# Fire Station at 1476 West Street

City of Attleboro  
ADA Transition Plan

April 2021

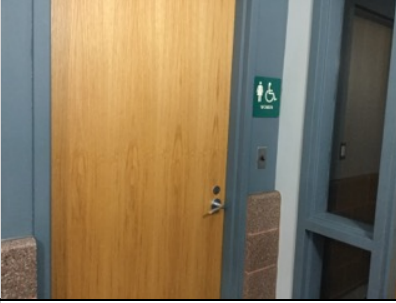
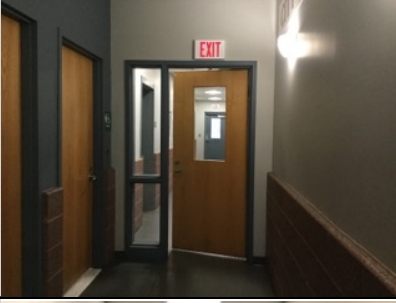
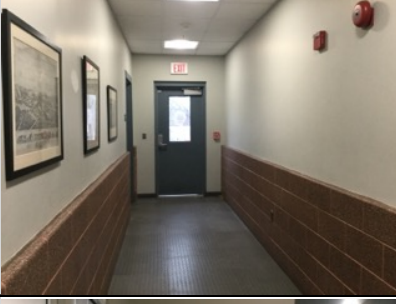
ID	Location	Floor	Room	Element	Type	Photo	Issues	Current Measure	Recommendations	Quantity	Price	Cost Estimation
<b>Approach and Entrance</b>												
<b>Off-Street Parking Lot or Garage</b>												
1	Accessible Parking	Ext.		Off-Street Parking Lot or Garage	N/A		Total # of parking Total # of designated accessible parking spaces Total # of designated van accessible spaces Sign bottom < 60" above finished grade	25 1 1 55"	Locate the International Symbol of Accessibility (ISA) identification sign at the car accessible parking space so it is 60" above the ground measured to the bottom of the sign.	1	Labor	\$0
<b>Exterior Stair</b>												
2	Exit Stair	Ext.		Exterior Stair	N/A		Handrail height < 34" or > 38"	42"	Handrails are slightly higher above the ground than required but usable.	1	-	\$0
<b>Emergency Exit</b>												
3	Main Entrance	1		Emergency Exit	N/A		Tactile sign not provided at exit	-	Provide tactile exit signs with raised characters and braille at exit doors. Mount signs between 48"- 60" above the finished floor located on the latch side of the door. If the exit sign is replaced with a new illuminated exit sign, provide an illuminated International Symbol of Accessibility (ISA).	1	232	\$232

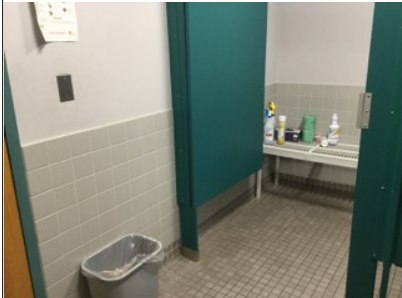
4	Main Entrance	1		Emergency Exit	N/A		Tactile sign not provided at exit Illuminated Int. Symbol of Acc. not provided (MAAB)		Provide tactile exit signs with raised characters and braille at exit doors. Mount signs between 48"- 60" above the finished floor located on the latch side of the door. If the exit sign is replaced with a new illuminated exit sign, provide an illuminated International Symbol of Accessibility (ISA).	1	232	\$232
<b>Access to Goods and Services</b>

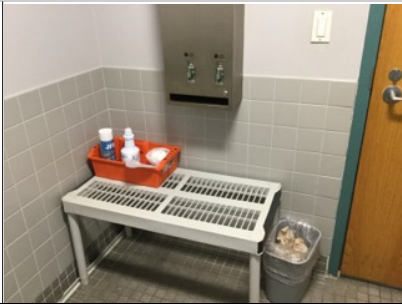
<b>Interior Access Route</b>												
8	Reception	1		Interior Access Route	N/A		Obstructed by protruding objects	-	Provide a cane-detectable barrier 27" max. above the finished floor at that accessible service counter.	1	306	\$306
<b>Doors, Doorways, &amp; Gates</b>												
9	Main Entrance	1		Doors, Doorways, & Gates	Circulation		Door requires > 5 lbs. of force to open	15 lbs.	Adjust closers so doors do not require more than 5 pounds of force to open.	1	Labor	\$0
